工程變更客戶通知單

ECR/ECN 單號： ECR/ECN Number:	EC-22-08-019
日期： Date:	2022/03/21
變更者/郵箱： Author/Mail	Verena Liu <vliu@taoglas.com>
客戶端工程變更需求確認：(signature) EC request confirmation by customer	請於 10 工作日內簽回，若超過 10 日未簽回將視為同意此變更 Please sign back within 10 working days, if you do not sign back within 10 working days, you will be deemed to agree to this change.
客戶端工程變更完成確認：(signature) EC completion confirmation by customer	請於 10 工作日內簽回，若超過 10 日未簽回將視為已確認 Please sign back within 10 working days, if you do not sign back within 10 working days, it will be deemed as confirmed.

變更類型 Type of Change	☒ 工程設計變更 Engineering Design Change	☐ 生產製程變更 Production Process improvement
	☐ 其他: Others:	
變更原因 Reason for change	The original double-sided adhesive of 3M 5666 was shortage in the market, we need to add two new types of 3M Adhesive (Both CP5112 and GPH-110GF) for production.	
變更說明 Description of Change	Add two new types of 3M Adhesive (Both CP5112 and GPH-110GF) in the drawing.

1. 變更前 / Before

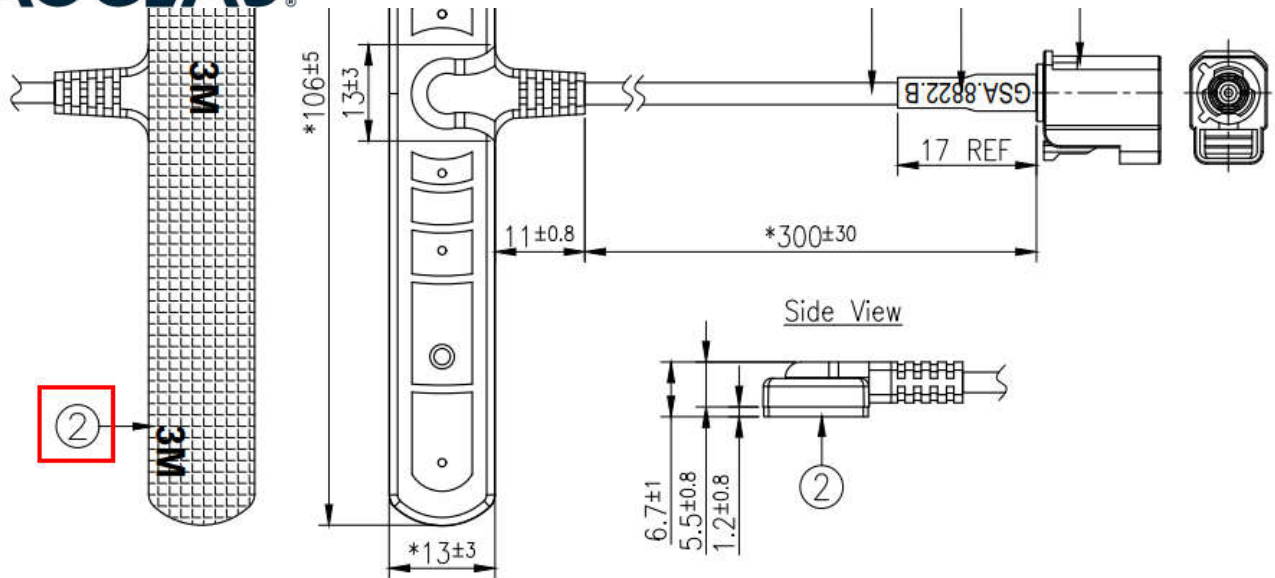
Name	P/N	Material	Finish	QTY
1	Housing	000115I000002A	PVC	Black	1
2	Double Sided Adhesive (Gray Foam)	001015I050002A	3M 5666	Red Liner	1
3	RG174 Coaxial Cable	301315C000000A	PVC	Black	1
4	Heat Shrink Tube (GSA.8822.B)	001318G090000A	PE	Black Tube/White Text	1
5	FAKRA Code D	202411G020003A	PA66	Violet	1

2. 變更後/After

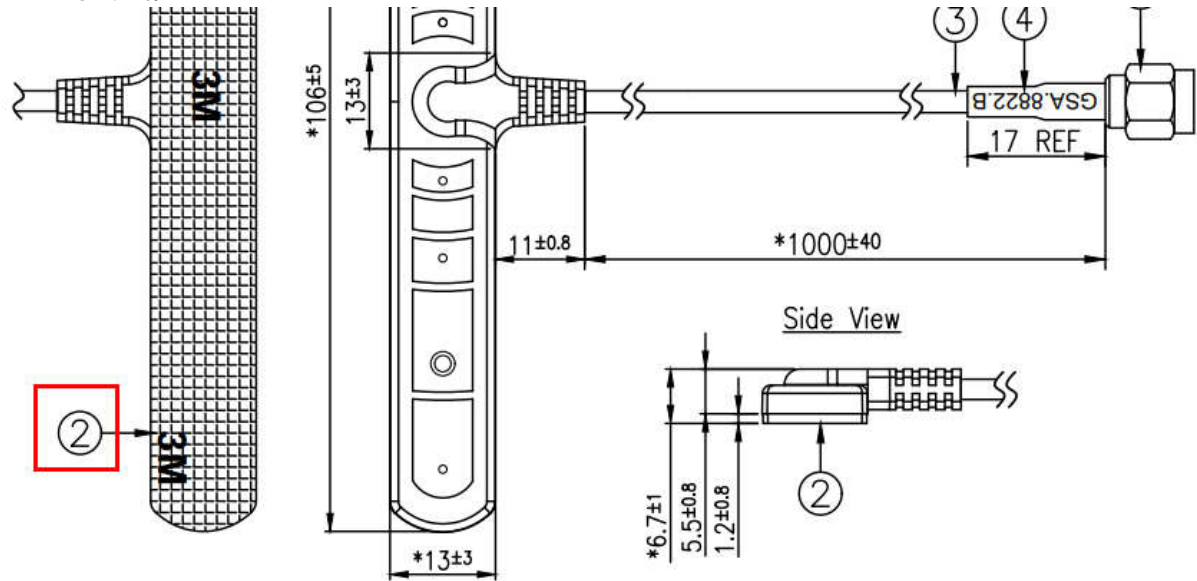
Name	P/N	Material	Finish	QTY
	1 Housing	000115I000002A	PVC	Black	1
△D	2 Double Sided Adhesive (Gray Foam)	001015I050002A	3M 5666 CP5112 GPH-110GF	Red liner/Silver text Red liner/Black Text Red liner/White Text	1
	3 RG174 Coaxial Cable	301315C000000A	PVC	Black	1
△B	4 Heat Shrink Tube(GSA.8822.B)	001318G090000A	PE	Black Tube/White Text	1
	5 SMA(M) ST	200213F000002A	Brass	Ni Plated	1
